The applicant requests approval of a site plan, landscape plan, and elevations for a 54 unit multi-family residential project.

Project Name: Courtyard at Main St. Plaza Scottsdale

Design Review and Site Plan approval of 'Courtyard at Main St. Plaza Scottsdale' - Phase II of Loloma PBD.

33-DR-2003#2

33-DR-2003#2
12/14/05
PRELIMINARY LANDSCAPE PLAN - SOUTH

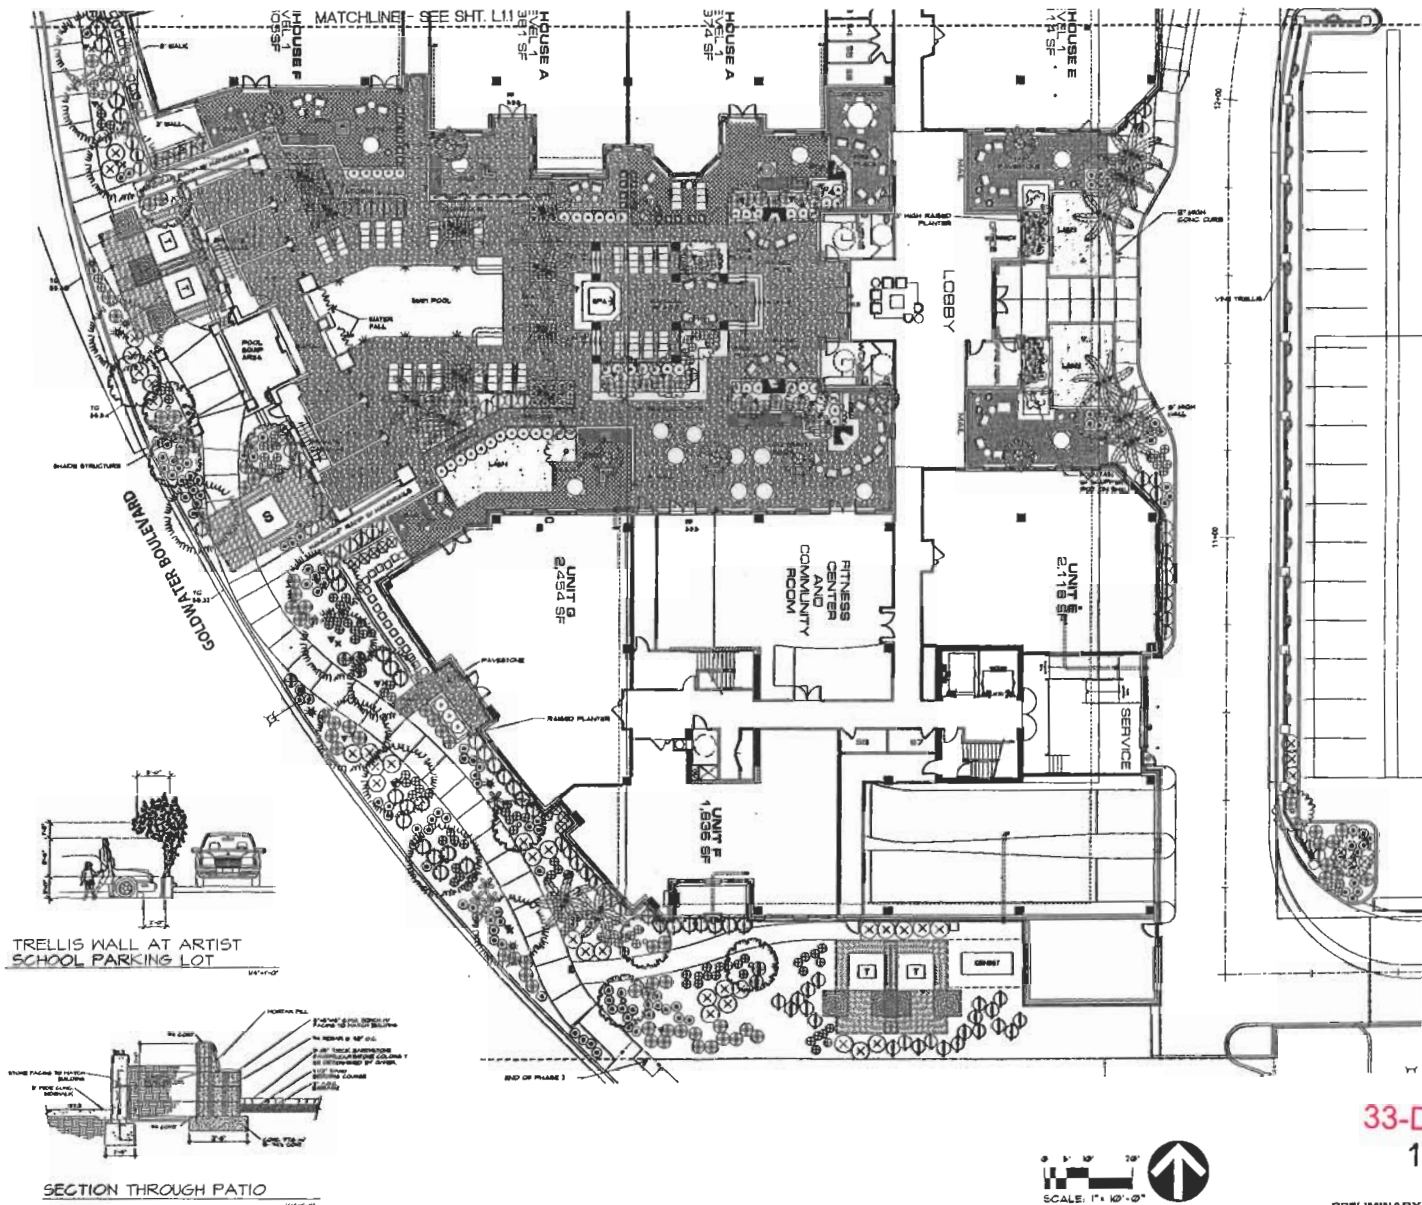
The street level landscaping along Goldwater Blvd. and Second Street consists of a variety of trees including the Chilean Mesquite, Arizona Ash and Collibah, providing shade and comfort at the pedestrian level. The applicant has also incorporated raised planters integrated with the building, a minor water feature and a shade structure with benches along the Goldwater frontage. Date Palms flank the entrance to the building Lobby on the East face of the project and a trellis wall separates the vehicular private driveway and the Artists School parking lot.

- c. Landscaping, including quantity, size, and location of materials shall be installed to be consistent with the conceptual landscape plan submitted by Arterra Inc. with a date provided on the plan by City Staff of 12/14/2005.

GOLDWATER BOULEVARD STREETSCAPE ELEVATION
NTD

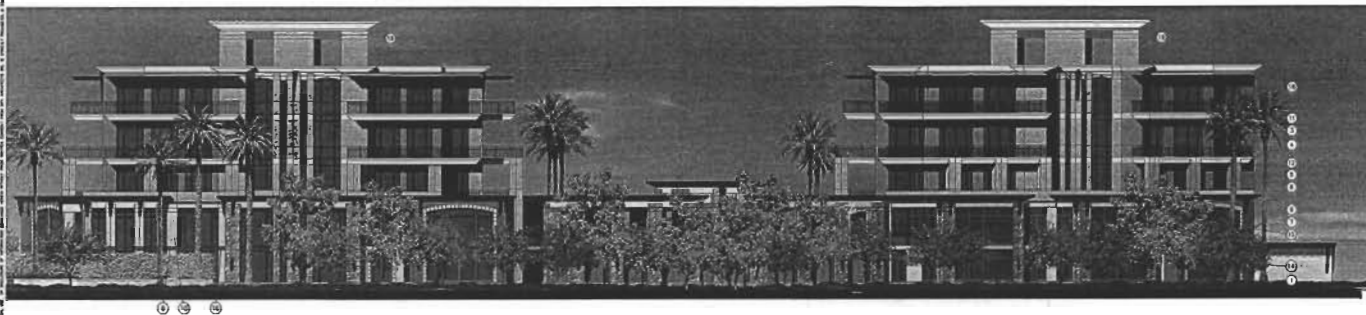
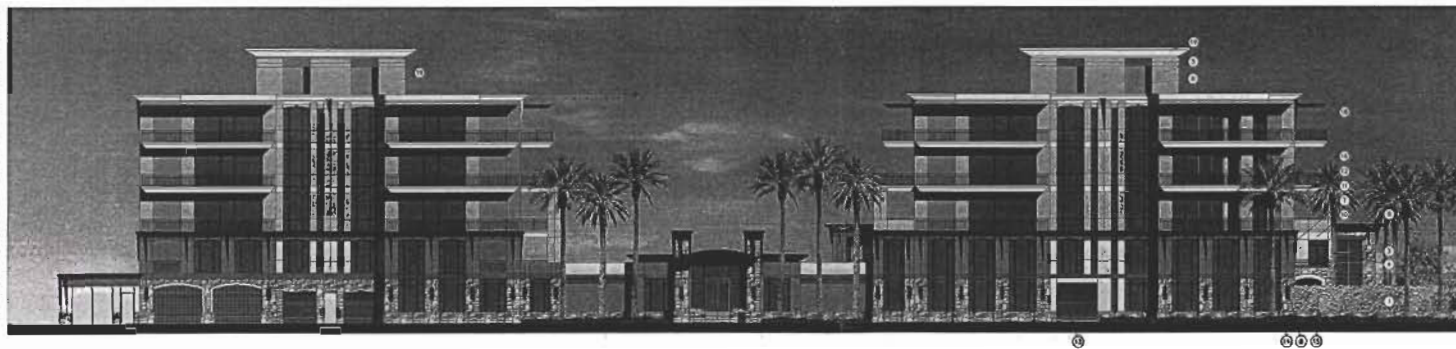
Along Goldwater Blvd., Building C originally presented a faceted building line that followed the curved configuration of the Couplet, providing a thirty-foot setback. A double tree lined sidewalk and shading features provided a unique street level amenity encouraging pedestrian movement along the perimeter and through the development. Building C wrapped around a central courtyard that included a swimming pool, spa, exercise room and resident amenities. Building mass was proposed to be broken by the stepped character of the west facade and the 2:1 and 2:2 corresponding inclined setbacks.

The site plan presents building facades along two adjacent streets: Goldwater Blvd. and Second Street. Building massing along the couplet frontage exhibits a 115-foot space between the two main structures, providing a significant visual break above the second level and allowing clear distinction between the primary buildings. Both buildings are linked by a strong horizontal two story building base which defines the character at the pedestrian level and houses the town-home product along Second Street and the Artists School edge. Throughout the buildings, a composition of sand and earth tones on the walls, window frames and balcony railings highlighted with warm gray accent bands and terracotta fascia elements complement the limestone building stone veneer.

PEDESTRIAN CIRCULATION DIAGRAM
ZONING: D/O C-2

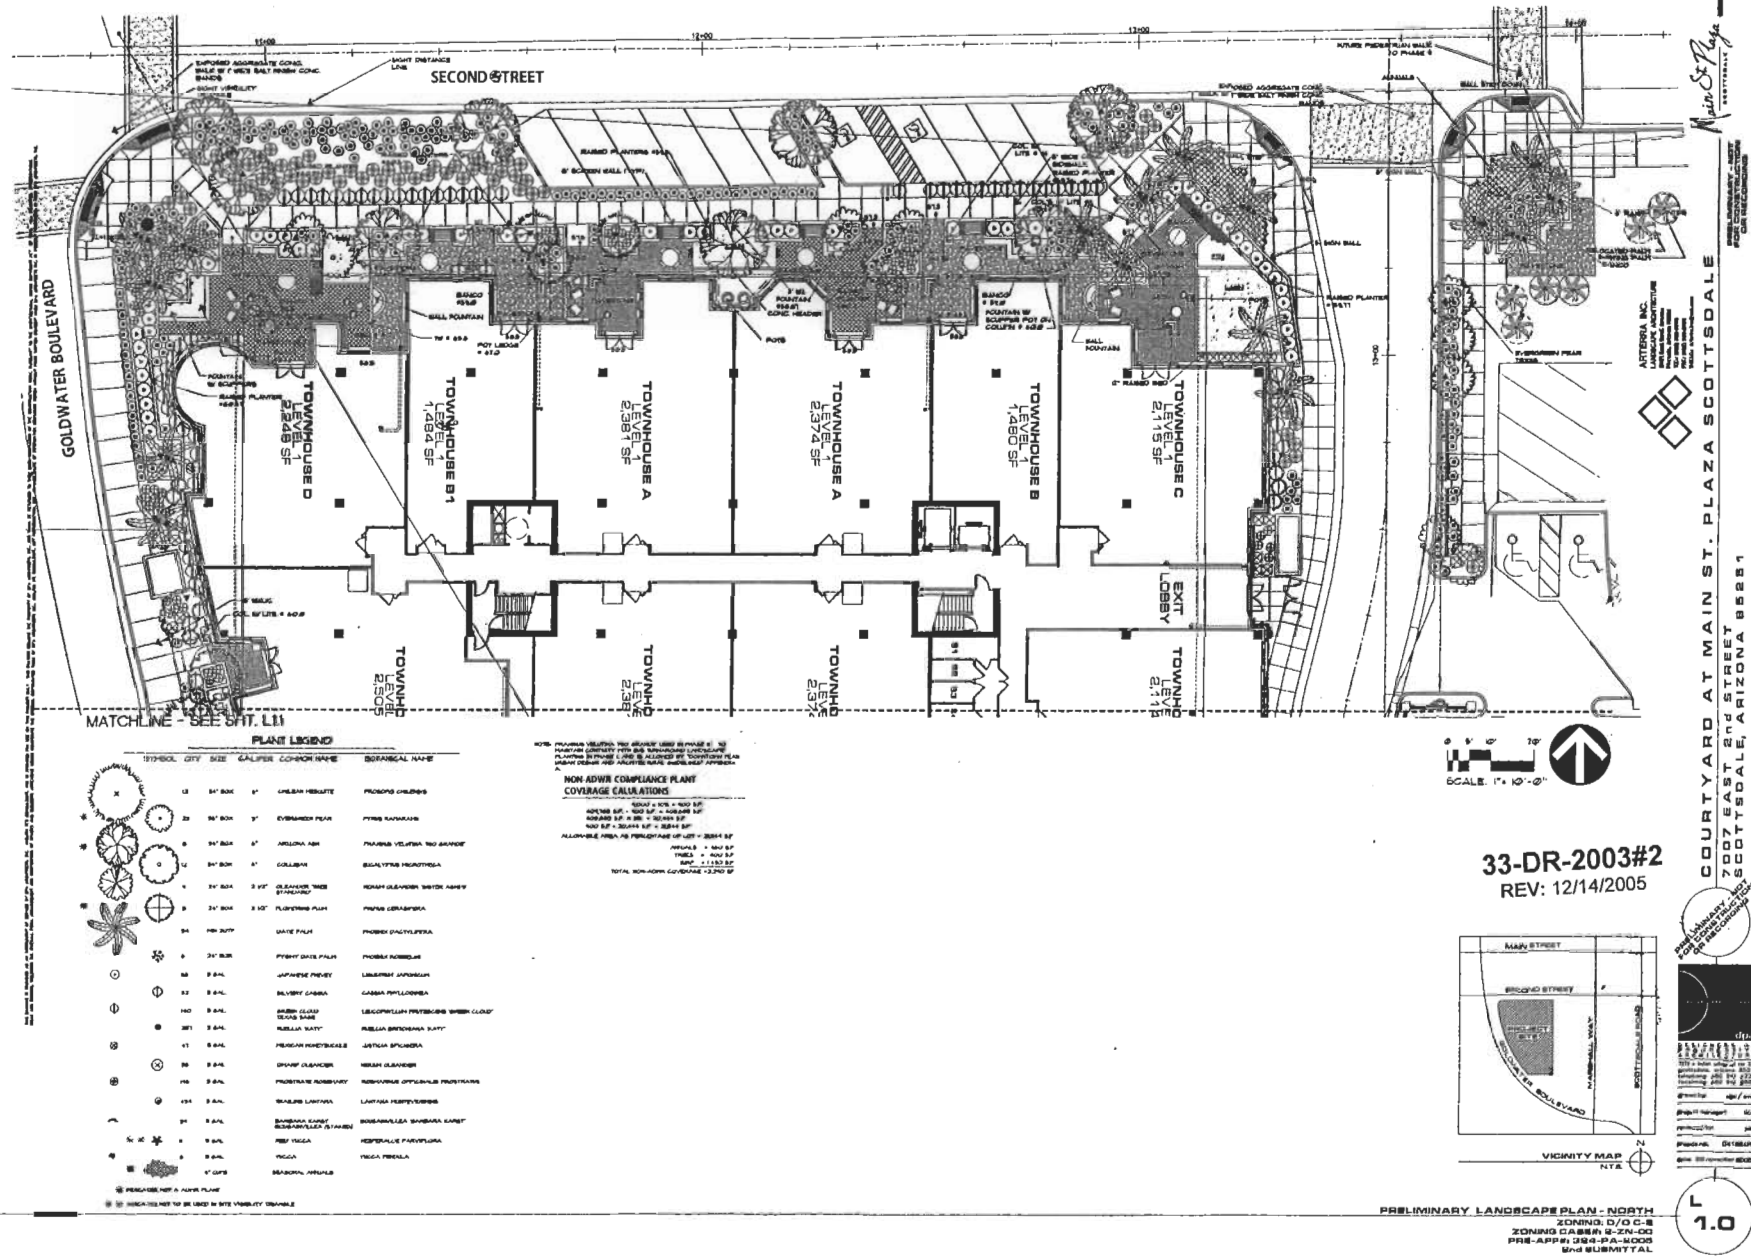
In the approved site plan, a north-south circulation spine connects pedestrian traffic from the Main Street retail corridor through the Transit Center to the southernmost residential project in the PBD. The proposed plan for Phase II modifies the circulation plan, diverting pedestrians along Second Street to

Marshall Way, and maintaining a minor pedestrian connection to the Artist School parking area. Vehicular traffic along the internal north-south proposed private driveway, leading into the underground parking garage has replaced the pedestrian corridor.

- Change to the overall pedestrian circulation system. The movement of the buildings and open spaces creates more of a focus on movement

Pedestrian circulation and connections will be in general conformance with the circulation master plan.
